ENGINE - FUEL AND CONTROL - REPLACE THE DATA ENTRY PLUG WITH ONE THAT HAS A REVISED WIRING SCHEME - CATEGORY CODE 3 - MOD.ENG-73-0055

V2500-ENG-73-0055

## SERVICE BULLETIN

Identification Data Entry Plug Assembly to The New Part Number  
Fig.8

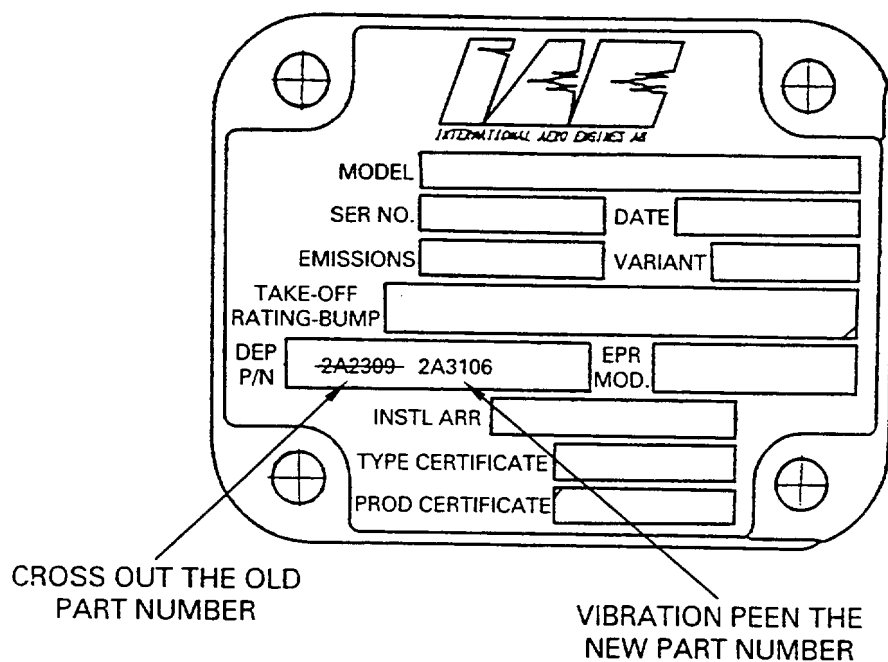
- (6) Identify the DEP backshell with the new part number by the procedure given in Reference (3), Chapter/Section 70-09-00, Marking of Parts.

- (a) Write the new part number 2A3106 CL01 and cross out the old part number 2A2309 CL3. See Figure 8.
  - (b) Use the vibration peen method.
- (7) Identify the Engine Identification Plate with the new DEP Assembly part number by the procedure given in Reference (3), Chapter/Section 70-09-00 Marking of Parts.

Mark The Engine Identification Plate  
Fig.9

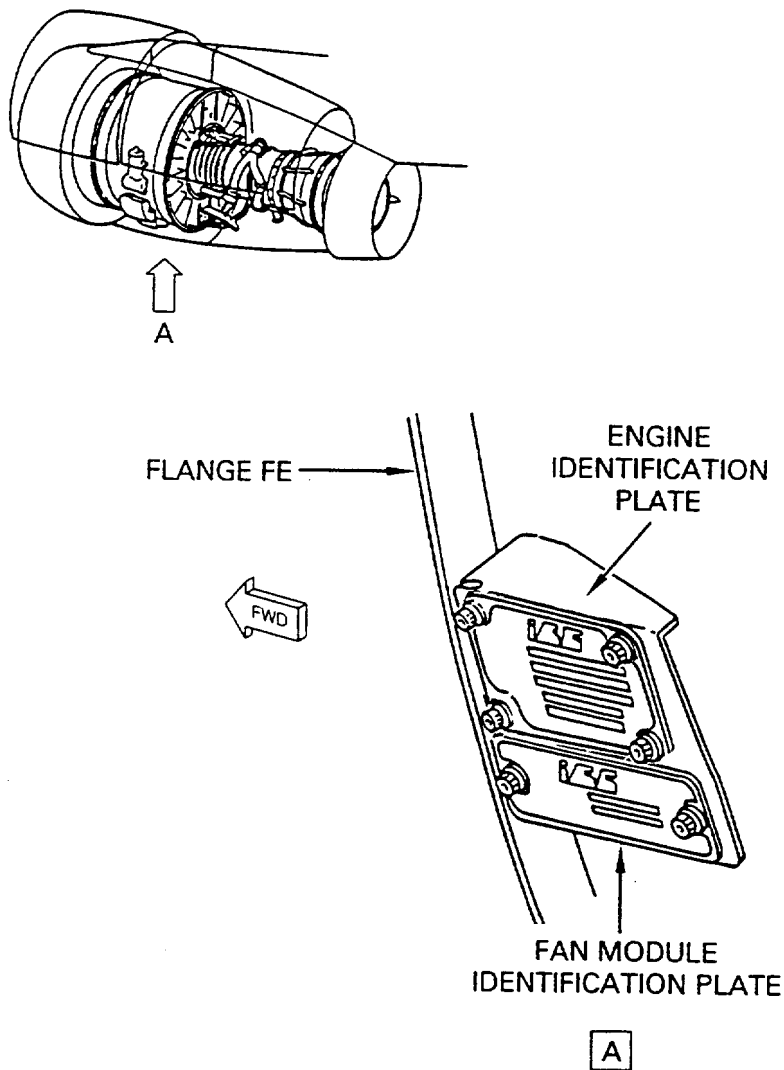
NOTE: If there is no area on the Engine Identification Plate to make marks, you will have to use a new Engine Identification Plate. Contact your IAE representative to obtain a new Engine Identification Plate.

- (a) Write the new part number 2A3106 CL01 and cross out the old part number 2A2309 CL3. See Figures 9 and 10.
- (b) Use the vibration peen method.

Data Entry Plug Configuration Modification (Configuration 2)  
Fig.11

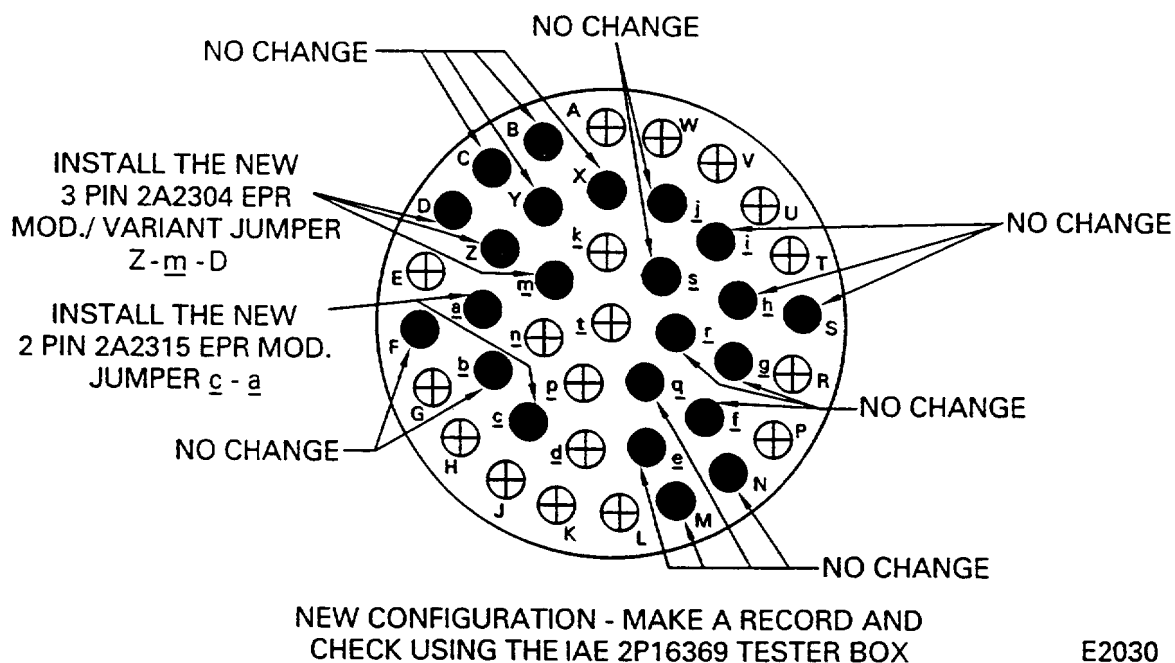
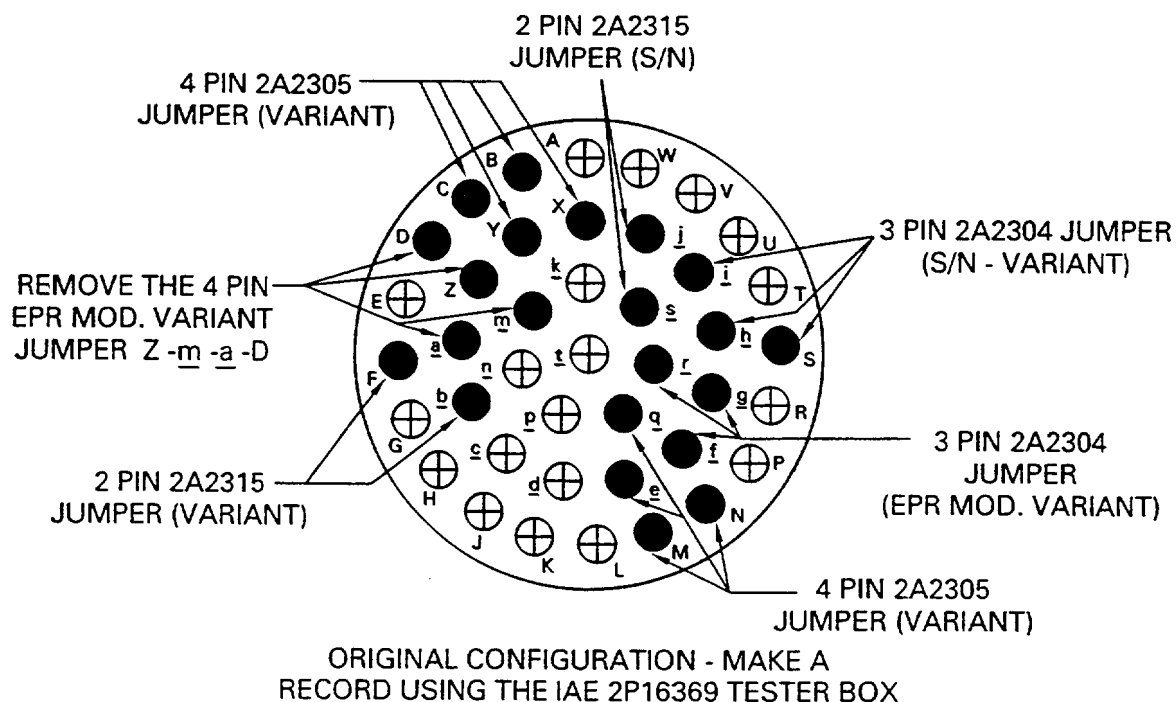
E. Rework Instructions – Condition 2 (For V2500-A5 Engine Serial Number V10024, V10060 and V10063 that incorporate the EPR modifier No. 07 configuration:

Procedure	Supplementary Information
(a) Remove the four pin EPR modifier jumper Z-m-a-D as follows:	Refer to Figure 11
1 Remove the jumpered wire contact pins.	Refer to Figure 6.
2 Use the MS27495R20 contact tool (1 off), or equivalent, and a small piece of straight wire, such as a straightened paper clip.	
3 Discard the jumper.	
(b) Install the 3 pin EPR Modifier/Variant jumper Z-m-D and the 2 pin EPR Modifier jumper c-a.	Refer to Figure 7 and Figure 11.

- 1 Use the procedure given in Paragraph C. Step (4), (d), substeps 1 through 6.
- (c) Install the 2 pin EPR Modifier jumper c-a by the procedure that follows:
  - 1 Put the new 2A2315 (2 pin) jumper into the MS27495A20 Contact Insertion Tool.
  - 2 Hold the connector with your hand.

Data Entry Plug Configuration Modification (Configuration 4)  
Fig.12

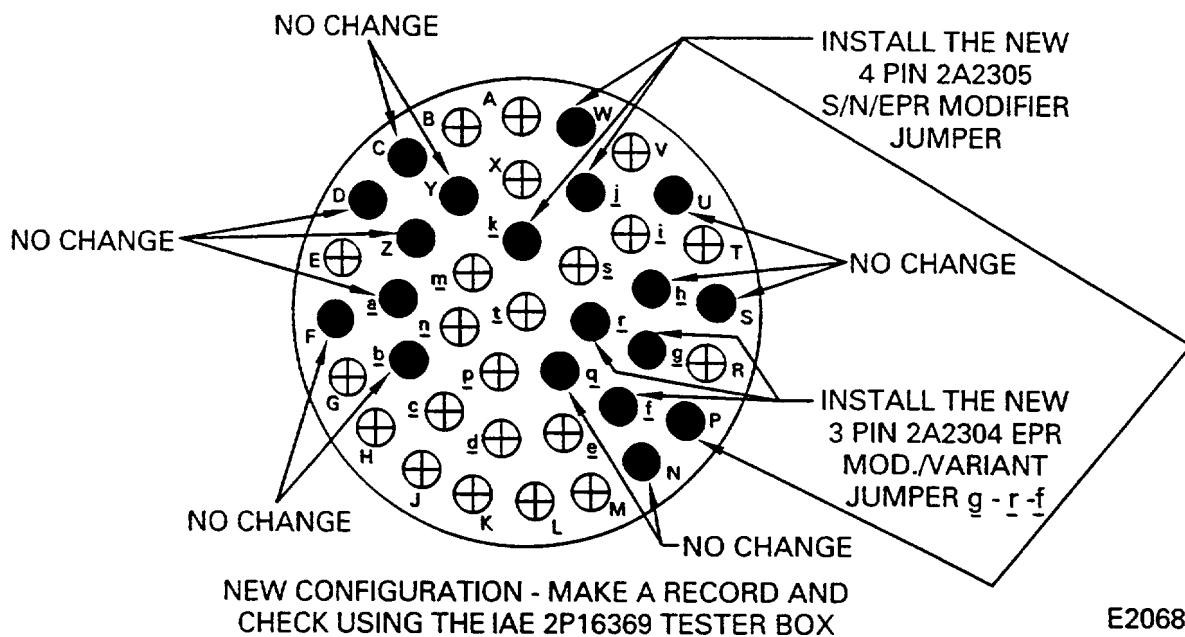
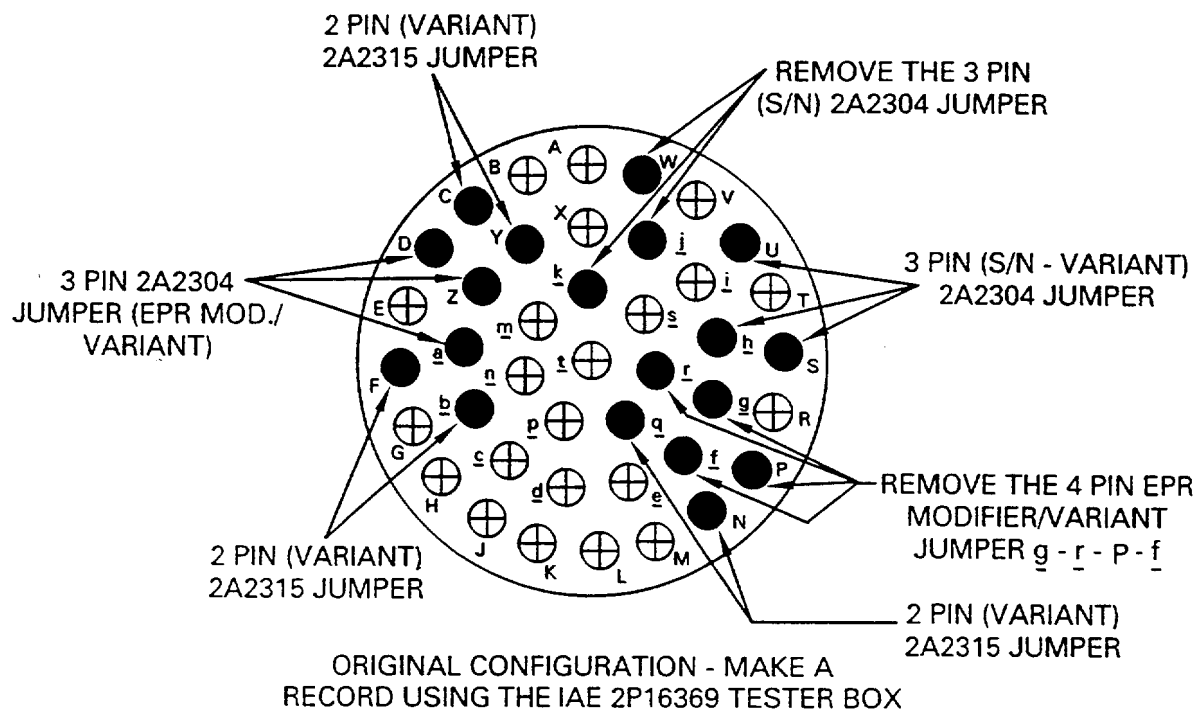
- (a) Locate the three pin serial jumper W-k-j and the four pin EPR Modifier/Variant jumper g-r-P-f.

- (b) Remove the three pin serial number jumper and the four pin EPR Modifier/Variant jumper as follows:

- (c) Install the new serial number/ EPR modifier jumper W-k-j-P.

- 1 Hold the connector with your hand.
- 2 Make a selection of the 4 pin jumper 2A2305.
- 3 Push the jumper ends into the connector holes W-k-j-P.
  - a Use your hands.

- (d) Install a new 3 pin (g-r-f) EPR modifier/variant jumper.

Data Entry Plug Configuration Modification (Configuration 5)  
Fig.13

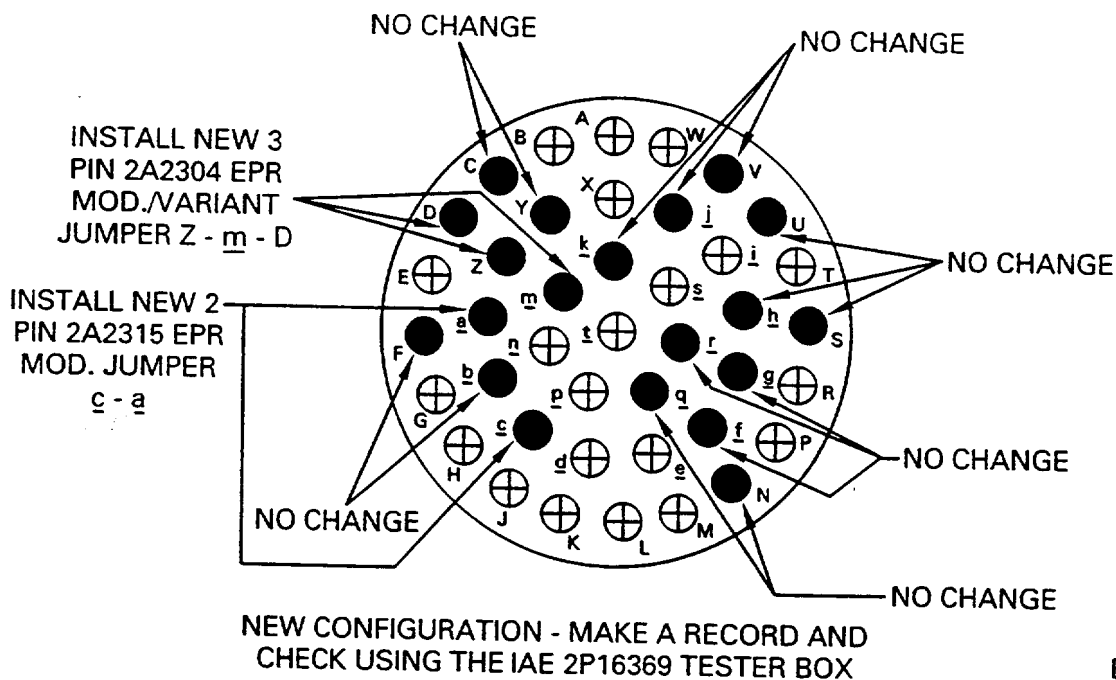
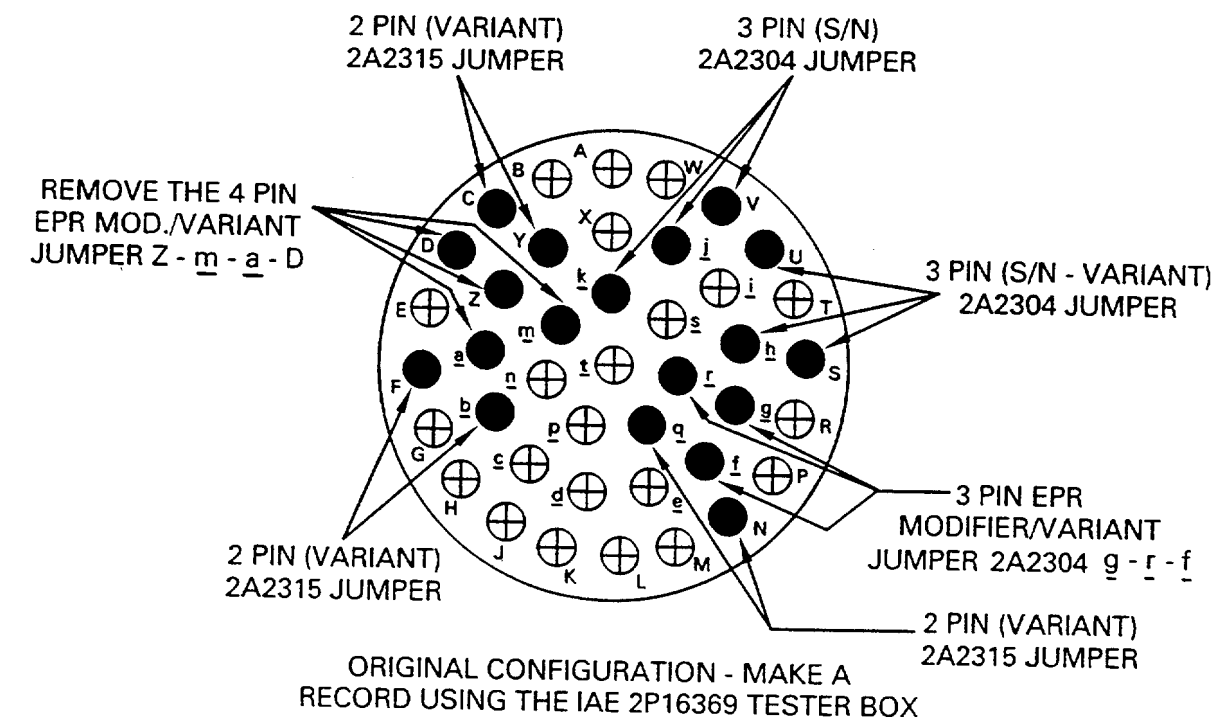
H. Rework Instructions – Condition 5 (For V2500-A5 Engine Serial Number V10038 that incorporate the EPR modifier No. 07 configuration:

Procedure	Supplementary Information
(a) Remove the four pin EPR modifier jumper Z-m-a-D as follows:	Refer to Figure 13.
1 Remove the jumpered wire contact pins.	Refer to Figure 6.
2 Use the MS27495R20 contact tool (1 off), or equivalent, and a small piece of straight wire, such as a straightened paper clip.	
3 Discard the jumper.	
(b) Install the 3 pin EPR Modifier/Variant jumper Z-m-D and the 2 pin EPR Modifier jumper c-a.	Refer to Figure 7 and Figure 13.
1 Use the procedure given in Paragraph C. Step (4), (d), substeps 1 through 6.

- (c) Install the 2 pin EPR Modifier jumper c-a by the procedure that follows:

- 1 Put the new 2A2315 (2 pin) jumper into the MS27495A20 Contact Insertion Tool.
- 2 Hold the connector with your hand.
